UNITED STATES PATENT AND TRADEMARK OFFICE

APPLICATION NO.	FILING DATE	FIRST NAMED INVENTOR	ATTORNEY DOCKET NO.	CONFIRMATION NO.
10/692,865	10/27/2003	Toshihito Yanashima	020265A	9185

Office Action Summary	Application No. 10/692,865	Applicant(s) YANASHIMA ET AL.	
	Examiner Nguyen N Hanh	Art Unit 2834

DETAILED ACTION

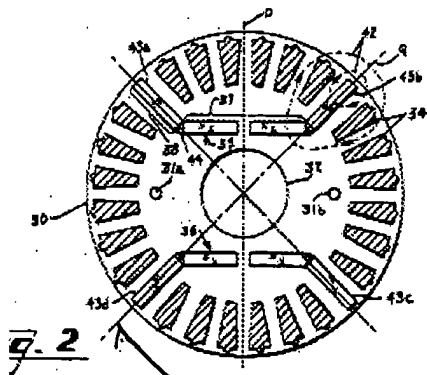
Regarding claim 5, Liu et al. also discloses a synchronous induction motor wherein a pair of the permanent magnets (35 and 36) is disposed, sandwiching the rotating shaft therebetween, and permanent magnets (43b and 43d) for attracting the magnetic field produced by the paired permanent magnets are further disposed at both ends of a line that passes the paired permanent magnets and the rotating shafts (please see mark-ups below).

Line that passes the paired P.M
